Land to the East and West of Church
Street, Cliffe, Rochester

Proof of Evidence

Health Impact

Planning Inspectorate Reference: APP/A2280/W/22/3313673
Local Planning Authority Reference. MC/22/0254

APPENDIX 4 - Drawing 0315 Rev 04 Parameter Height plans – extracted from Design and Access Statement section 7.4:

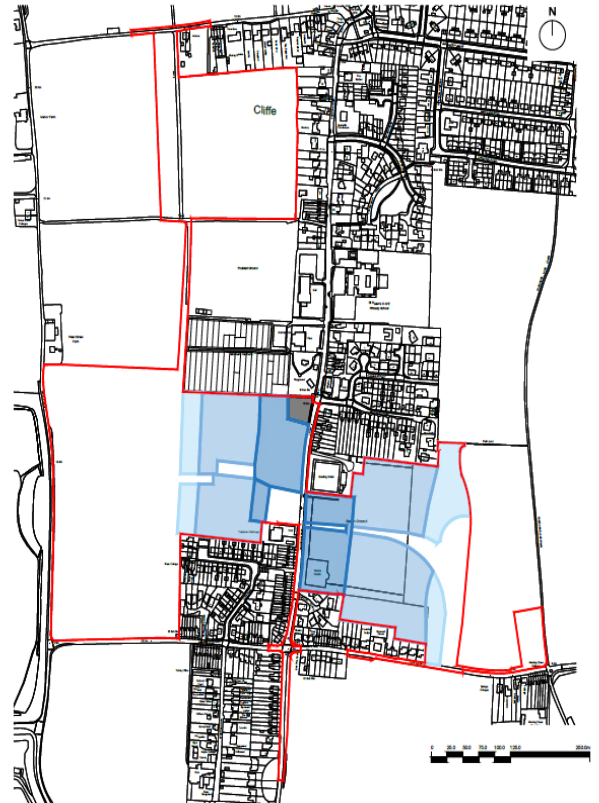
3.10 Drawing 0315 Rev 04, Parameter Height Plans (Appendix 4), does not identify a single

Parameter Plan, with higher buildings (up to 2.5 storeys) focussed along Church

3.11 There is no indication on the drawing or in the Design and Access statement of the

3.12 The appellant has chosen to exclude a block colour on the drawing to reference those

3.13 The CCW RDG question what information was used to score this impact in the HUDU

3.14 The application therefore does not provide or plan for any accessible homes at single

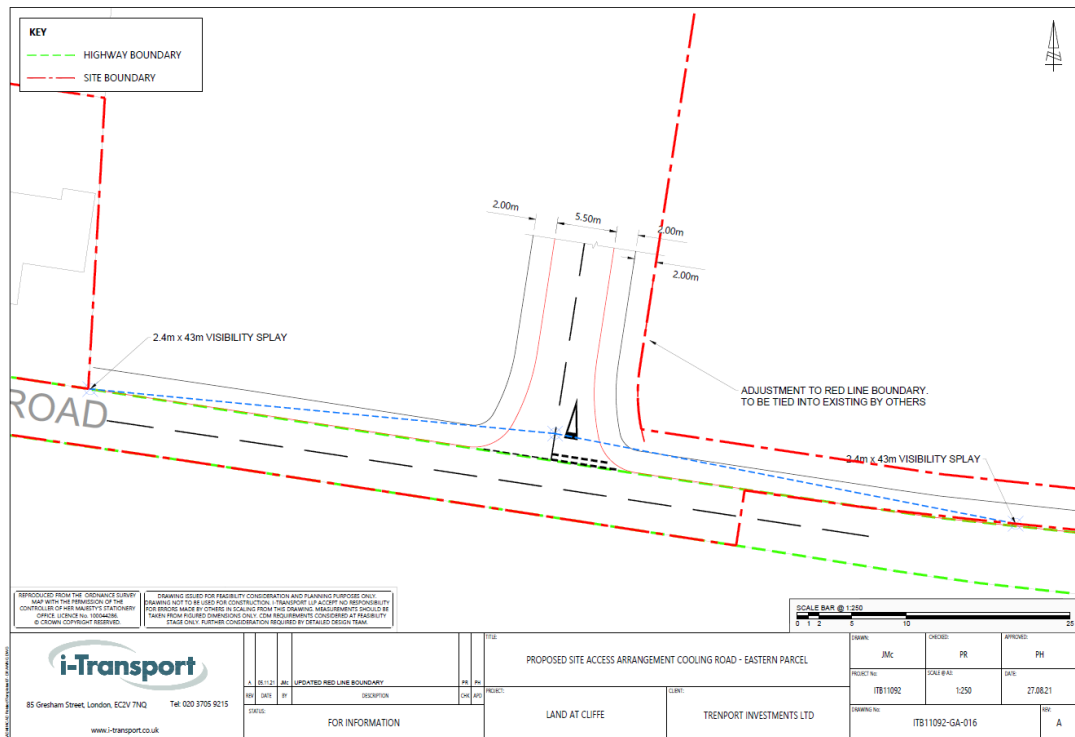
The documentation submitted by the appellant includes the Transport Assessment, drawing ITB11092 figure 1 attempts to demonstrate how residents are likely to use the public rights of way to access the new sports facilities instead of Buttway Lane. If these access points are to be relied upon, then we believe that further information would be required to enable a design decision based on suitability as the current footpaths do not even provide cycle or disabled access as a minimum.

Can you please ask the appellant to confirm, what 'access' is to be determined for this outline planning application stage with regards to access to the new APCM site.

Once the access has been clearly defined, we request that for clarity all other references to access routes not to be considered that are contained with the appellants documentation to be removed.
